SAN ANTONIO PLANNING COMMISSION

PARK HILL AT THE HEIGHTS
AT S. O. PUD, POD B U-1
SUBDIVISION NAME

050309

RE: Park Hill at the Heights at Stone Oak, Pod B Unit 1, Plat # 050309
Request for variance to centerline offset of intersections.

**INTERSECTION
B6**

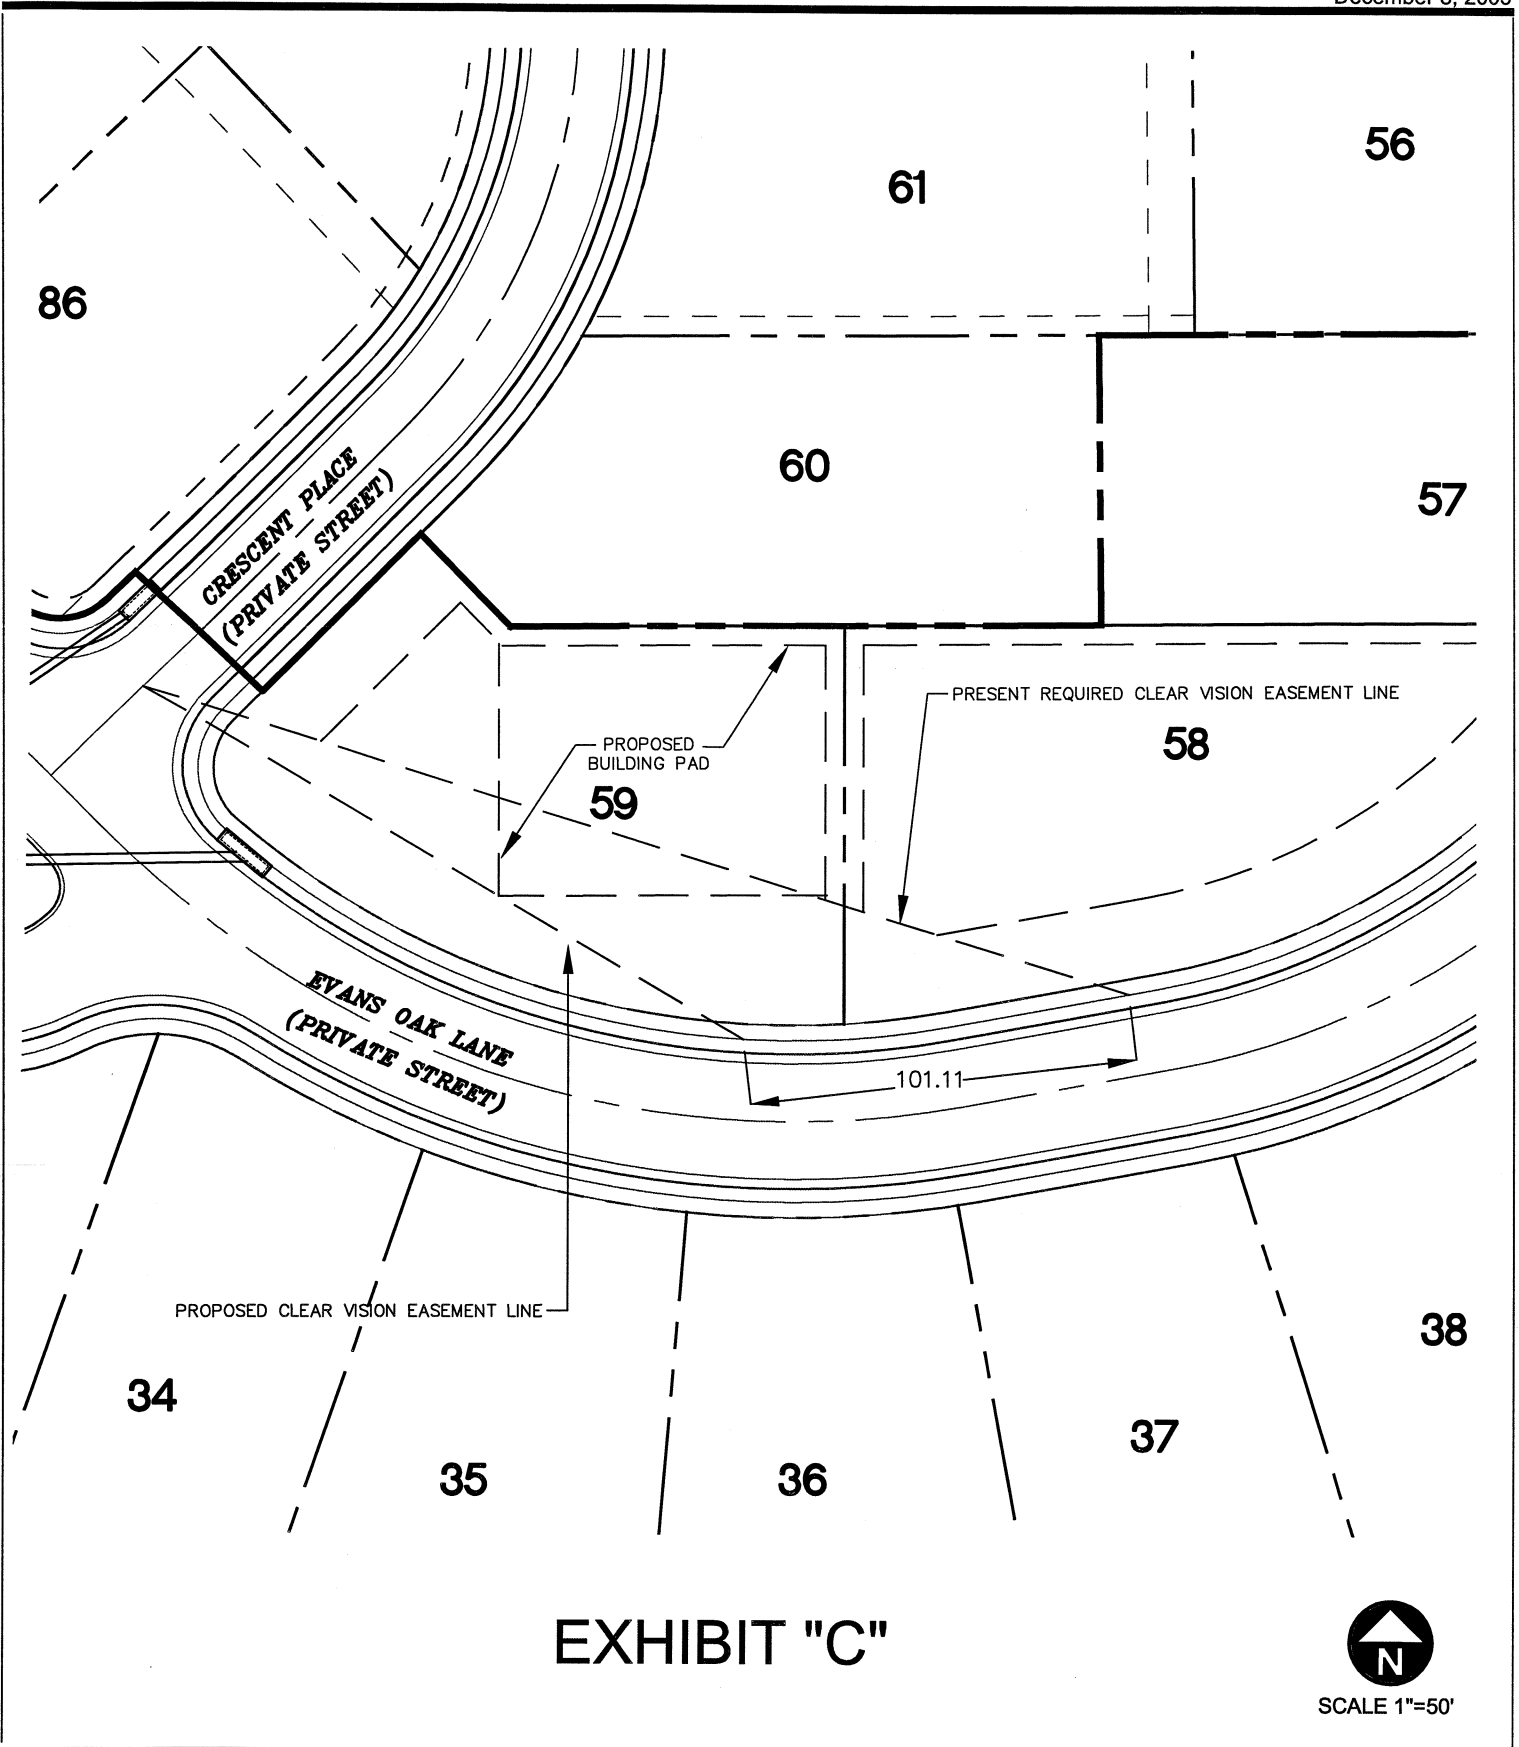
Intersection B6 is required by "UDC 35-506(f), to be at least 175 ft apart from all other intersections. The intersection of Park Hill Drive and Crescent Place to the intersection of Park Hill Drive and Evans Oak Lane as currently designed is approximately 90 ft. According to Chapter 9 of the AASHTO's – A Policy on Geometric Design of Highways and Streets this required distance is set to allow for an adequate functional area on the approach to an intersection. There are three basic elements: (1) perception-reaction distance, (2) maneuver distance, and (3) queue-storage distance that are combined together to provide for this functional area at intersection approaches.

In the case of intersection B6: (1) the perception-reaction distance is greater than 175 ft. Since there is a common area southwest of lot 79 that allows someone turning right from Evans Oak Lane onto Park Hill Drive has over 175 ft. of sight distance. Someone turning left from Evans Oak Lane onto Park Hill Drive also has more than 175 ft. of sight distance because Park Hill drive has a 80' wide right-of-way which taken with the distance between intersections B6 and Park Hill Drive and Evans Oak Lane is greater than 175 ft. (2) the intersection does not have a left-or right-turn lane, so there is not a required maneuver distance, and (3) Park Hill Dr. does not have a stop sign at the intersection with Crescent Place therefore no queue storage distance is required. We feel that the intent of the 175' spacing requirement is met.

Along the length of Park Hill Pass (the entrance street to POD B) there are two intersections located approximately 90 feet apart. The UDC requires a centerline offset between intersections of 175 feet. While intersection offsets less than the minimum normally creates safety concerns about left turn conflicts, several steps have been taken by the engineer to relieve said concerns for these two intersections. The primary turning movement at the intersection of Crescent Place and Park Hill Pass should be to the right in order to exit the subdivision. Turning movements to the left should be limited which will reduce left turn conflicts. In addition, an island has been designed between the two intersections to minimize the possibility of left turn conflicts. As indicated in the variance request letter, no stop sign exists on Park Hill Pass at Crescent Place that would create queuing problems at the intersection of Evans Oak Lane. There appears to be adequate stopping and sight distance at the two intersections for vehicles turning onto Park Hill Pass from Evans Oak Lane. Drivers stopped on Crescent Place should be able to see all approaching motorists prior to starting turns in either direction.

Since the design of the two intersections with the presence of the island should not create vehicle conflict safety concerns, DSD – Traffic Impact Analysis & Streets ***does not offer any objection*** to the approval of this variance.
